Clongriffin to City Centre Core Bus Corridor Preferred Route Option

Second and Third Public Consultation Submissions Summary Report

September 2021

Section 2: Belmayne to Coolock

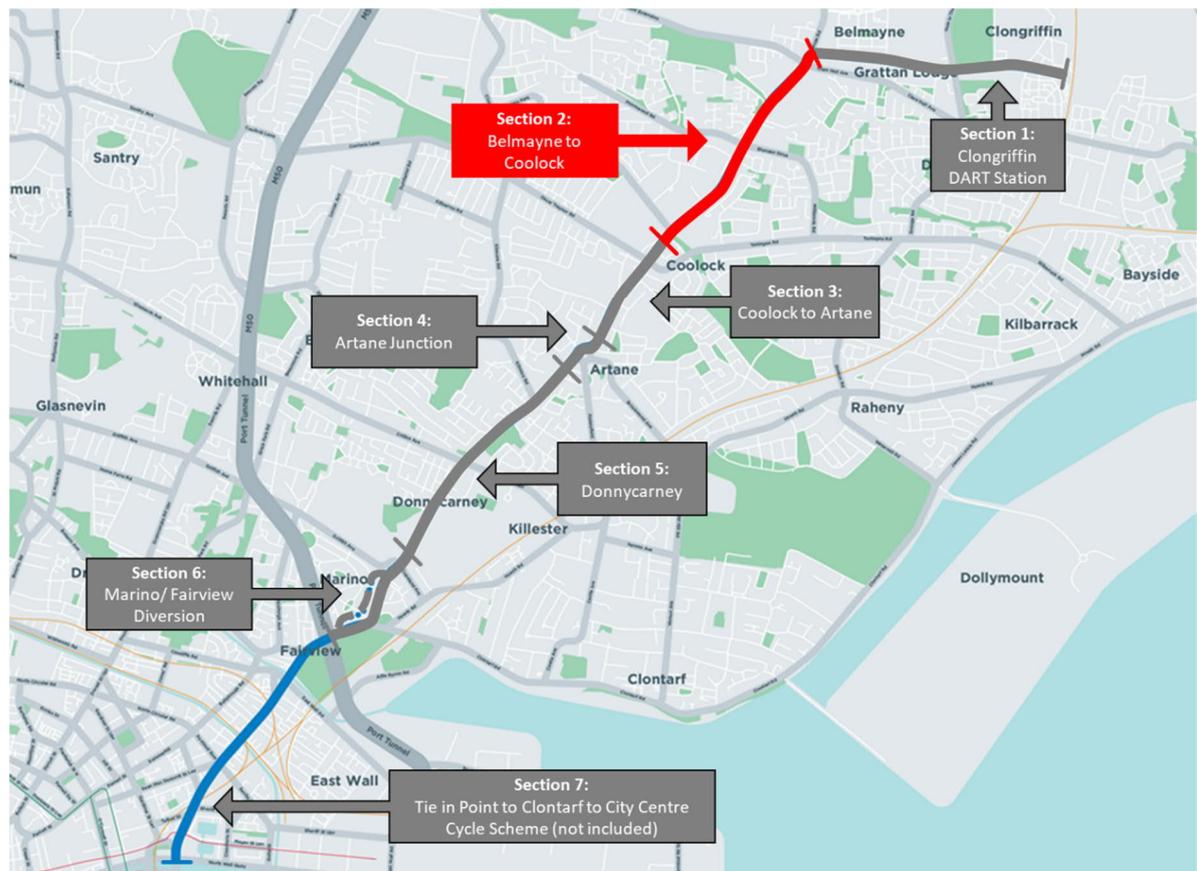
- Suggestion that the traffic light system at the junction of Belmayne Steet Avenue bus exit would allow a right turn for vehicles exiting from the street immediately opposite - currently there is a no right turn sign at this junction.
- Suggestion that it would be safer to include a cycle lane that could be extended on the Belmayne side of Clarehall Avenue rather than just on the Clarehall Shopping Centre side.
- It was noted that the plan for Clare Hall Junction on Malahide Road includes enhanced pedestrian and cyclist facilities. The current situation at that junction

is extremely cumbersome for pedestrians to navigate e.g. to get from Tesco to Hilton. It is welcomed that pedestrians are being considered in the plan, and that facilities at this junction will be enhanced.

- It was noted that there are large areas of hard-landscaping at corners of the main junction with possible opportunities for greening. Planting along the central medians is welcome.

- A resident has suggested that there could be a reduction of lanes on Malahide Road between Belcamp Parkway and Northern Cross, allowing for a boulevard-style street design. They say this would be possible if the Belcamp Parkway proposed in the DCC draft masterplan is designed as a main trunk route to relieve traffic from Malahide Road. It is also suggested that southbound traffic could be diverted onto Belcamp Parkway, allowing for the removal of a southbound traffic lane on Malahide Road, as well as the removal of the right turn lane from R139 onto Malahide Road. (Map 6, 7)

- Suggestion that the bus stop is located beside a brown field site that currently has planning permission submitted for a block of apartments. A small CPO here could be incorporated into the development. Alternatively move the bus stop closer to the city and use the green space at Grove Park to provide for a bus stop island.
- Suggestion to add more grassed verges at the Belcamp Parkway Junction.
- A resident voiced opposition to the removal of a bus stop at the Clarehall Junction as it may cause accessibility issues for older people wishing to use bus services. (Map 7)
- A resident expressed concern of the impact the removal of slip roads at Clarehall Shopping Centre may have on traffic. (Map 7)

- Suggestion that pedestrian crossings through the medians should be aligned in a straight run rather than staggered.
- A Residents Association expressed concerns regarding east-west traffic at the Oscar Traynor Road-Malahide Road junction and at the Artane Roundabout due to increased activity and future developments planned in the area. The group asks if a traffic impact survey has been carried out for current and future traffic conditions for the new signalised junction layouts. (Map 8)

- Suggestion to insert a buffer or physical barrier between the cycle lane and the bus lane on maps 8,9 and 10.
- Concerns about the lack of buffer space between the cycle track and the adjacent traffic lane particularly at the petrol station on the Malahide Road. Requests that cycle track be located beside the footpath with the grass buffer between the cycle track and the road.
- Suggestion to add more grassed verges at the Northern Cross Junction.

Section 4: Artane Junction

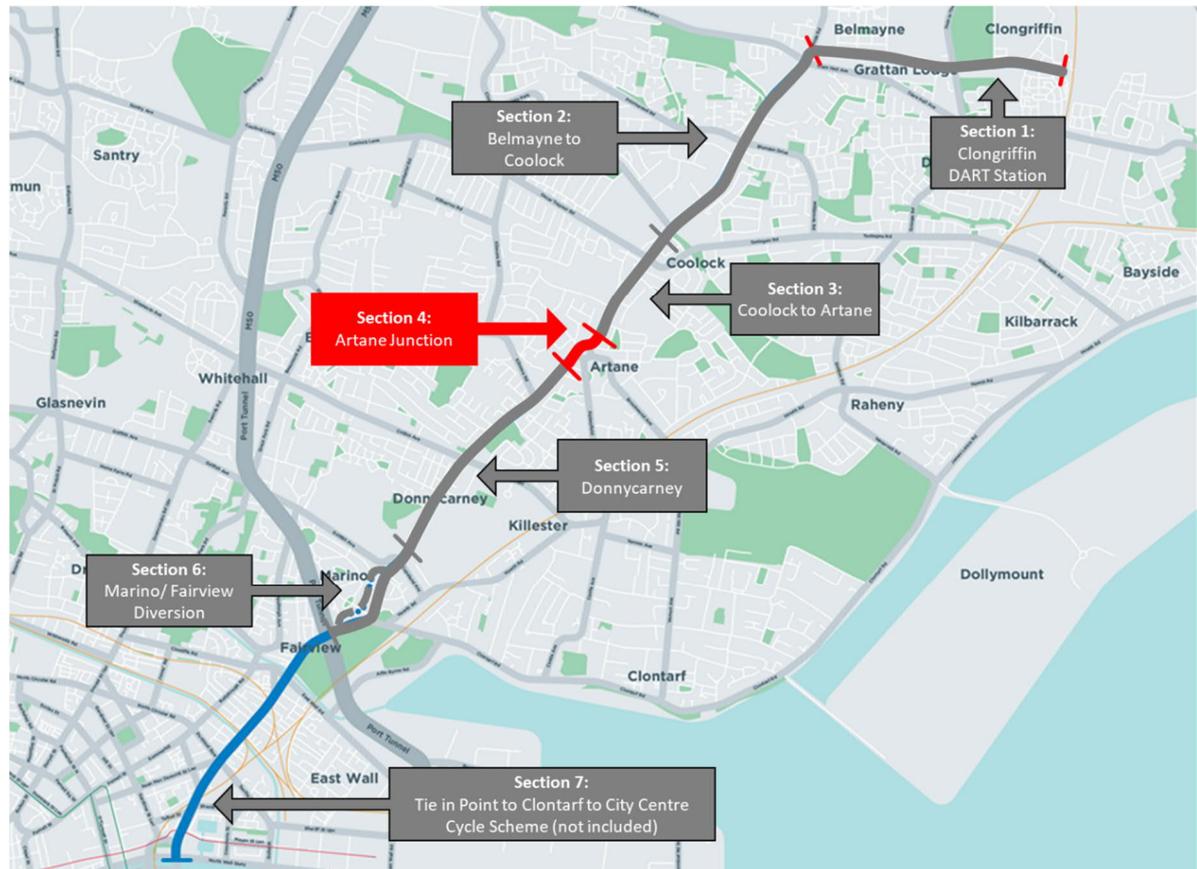
- It was suggested that a small CPO of a front garden could provide for a bus stop island.
- It was noted that there is significant local concern that the remodelling of the Malahide Road/Gracefield Road/Ardlea Road roundabout to a fully signalized junction will slow down traffic flow, particularly at peak hours. Also, consideration for light sequencing to prevent reduction in flows requested.
- It was noted that Map 14 & 15 there was Bus stops removed in both directions
- Concerns raised that there may be poor uptake of new cycle facilities if there is not sufficient encouragement. Coolock Residents Association cite ongoing experience at Artane Roundabout where many cyclists do not use the cycleway,

- A Malahide Road resident voiced their opposition to land take as part of the CBC01 plans, and expressed concern over the amount of their garden that would be lost under current plans. They also state their desire to reach a compromise with the NTA for themselves and their neighbours. (Map 14)

- It was noted that a pedestrian safety concern (from a potential assault) here is the lowered wall bordering the Pinebrook estate and St. David's - if a new boundary wall is being built in its place would it not be more beneficial to remove the wall completely rather than lower it so it could not be used to corner someone against?

- Objection to proposed bus stop move. It was stated that "The rationale for your proposed move is to relocate the bus stop closer to Killester Avenue and the pedestrian facilities at the junction. The new proposed location does not achieve this. Also planned is the reduction of the footpath to 2 meters. The proposed location of this bus stop is at the narrowest point of the current footpath which is plus 3 meters. The current location has approx. 5 meters of footpath. Moving the bus stop directly outside the homeowner's door would block both the homeowner and the neighbour's sightlines and would impact on entering and exiting the property. This is one of the busiest transport routes in and out of the city centre any potential bus stop moves should be considered carefully regarding road safety. Moving the stop to the proposed location could deem the driveways unusable as we would not be able to enter\exit the properties safely as our sightlines would be impaired by both a bus stop\shelter and pedestrian waiting for the bus."

- It was noted that there is a proposal to remove the current bus stop located at Daniele Road Artane. This will now make the gap between the Artane Roundabout and Killester Avenue bus stops in excess of 600m. It was noted that the respondent was in favour Bus stop rationalization the new distance will be greatly in excess of the 400m average. The respondent proposed that if that bus stop is to be moved it is moved to the opposite side of the traffic lights in map 16. This is where the pedestrian crossing is. Note there is no pedestrian crossing on the near side of Killester Avenue. If the stop should be located on the near side of Killester Avenue in map 15. The stop should be moved closed to the junction at the green space indicated on the map. The open green space would allow a number of options including bus lay by or wrap around cycle lane. A third option would be to move it closer to Kilmore Road which allow a more even distance (400m) between the 3 bus stops in the section. (Artane Roundabout\Killester Avenue and Donnycarney Park)

- It was noted that the wall between Malahide Road and St David's Wood is indicated to be lowered. It was unclear if this was to provide an acoustic / security function for neighbouring housing. Further detail was required.

- Request for a bus stop island where there is a planned CPO of the park.
- It was understood there is a conscious effort to keep the heritage wall in place. In this instance it was proposed to route the cycle track inside the wall or knock and rebuild a portion of the wall with a small curve for a bus stop island.
- Concerns raised over speed limits on Malahide Road being ignored, particularly by HGVs in evenings when the Port Tunnel is closed. Resident says a lack of enforcement means it is "an accident waiting to happen". (Map 16)
- A resident expressed concerns over air quality for cyclists and pedestrians; suggested that more trees be planted on Malahide Road. (Map 16)
- A resident suggested that digital speed displays be installed, and that Gardaí have a stronger presence on Malahide Road to help combat motorists breaking the existing speed limits. (Map 16)

- It was noted a turn right filter lane on the Malahide Road southbound side of the Collins Avenue junction - this is welcome particularly if accompanied by a traffic filter light sequence.
- It was noted that additional tree planting along the Church carpark boundary would be a nice gesture to the local community.
- Suggestion to close the Elm Road junction, due to it being another entrance off the Malahide Road that creates another conflict point with people cycling.
- A resident has expressed their strong opposition to the loss of any trees around Donnycarney Church and opposes the loss of trees on the route as a whole. (Map 17)

- It was noted that bus stop opposite Clancarthy Road removed.
- It was noted that there are greening opportunities along the central medians for low level planting and at some of the junctions.

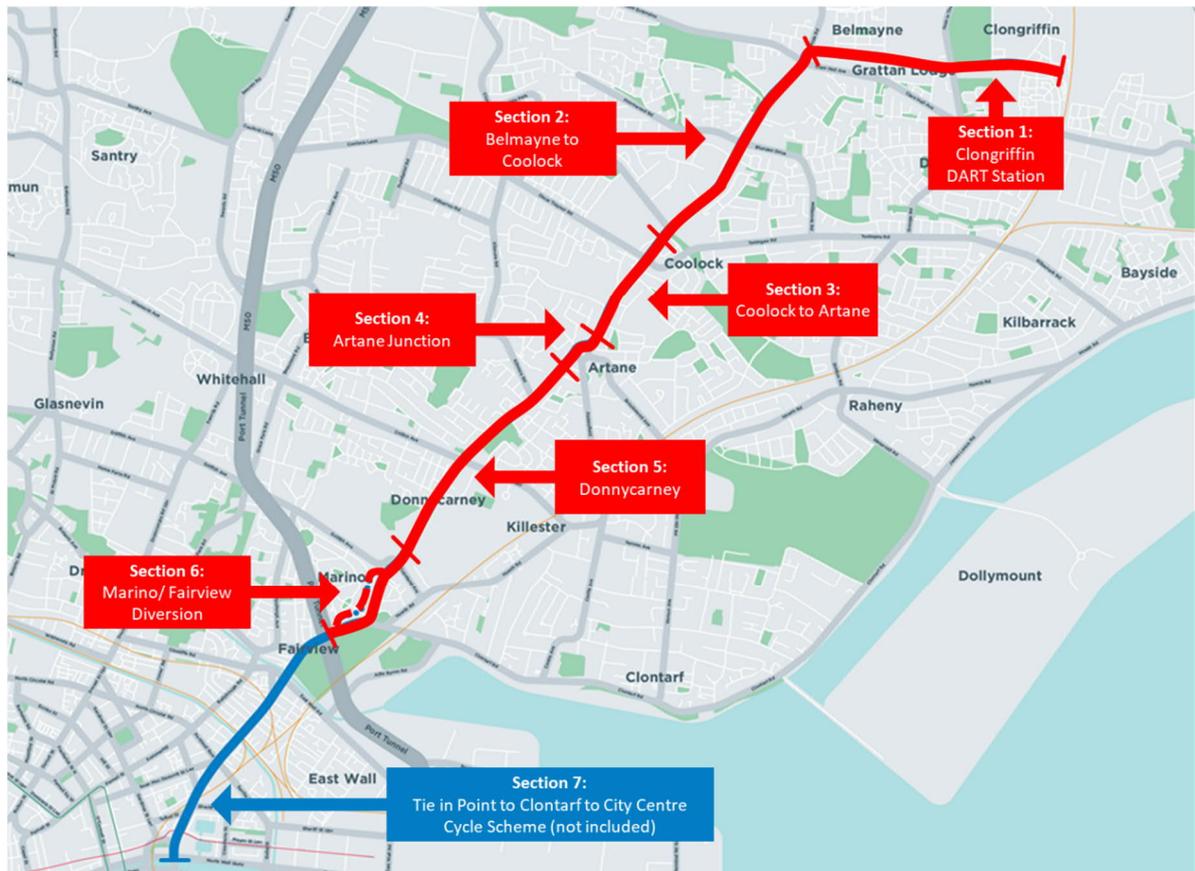
- It was much welcomed that the proposal, set out in the new plan, to block one end of Haverty Road to motor traffic. It was stated that This has always been the preferred solution for residents on the road, in order to make it safer for cyclists and pedestrians. It was stated that they have outlined our concerns in previous submissions, re high risk of volume of traffic and speeding traffic for older people using the road to go to shops and post office, school children attending the local school, increased number of children living on the road, number of cyclists who regularly use the road, especially during rush hour.

- A resident has voiced concerns over speeding cyclists along quiet streets, such as Haverty Road, and supports measures to encourage slower and safer cycling in these areas, such as ramps. (Map 21)

- A resident of Carleton Road suggests that action should be taken at the St Aidan's Park Road/Carleton Road/Haverty Road junction to calm traffic. Suggestions include widening the footpaths and reducing the turning radius in order to encourage road users to yield. The resident says the current yield signs are frequently ignored and changing them to stop signs is insufficient. (Map 21)
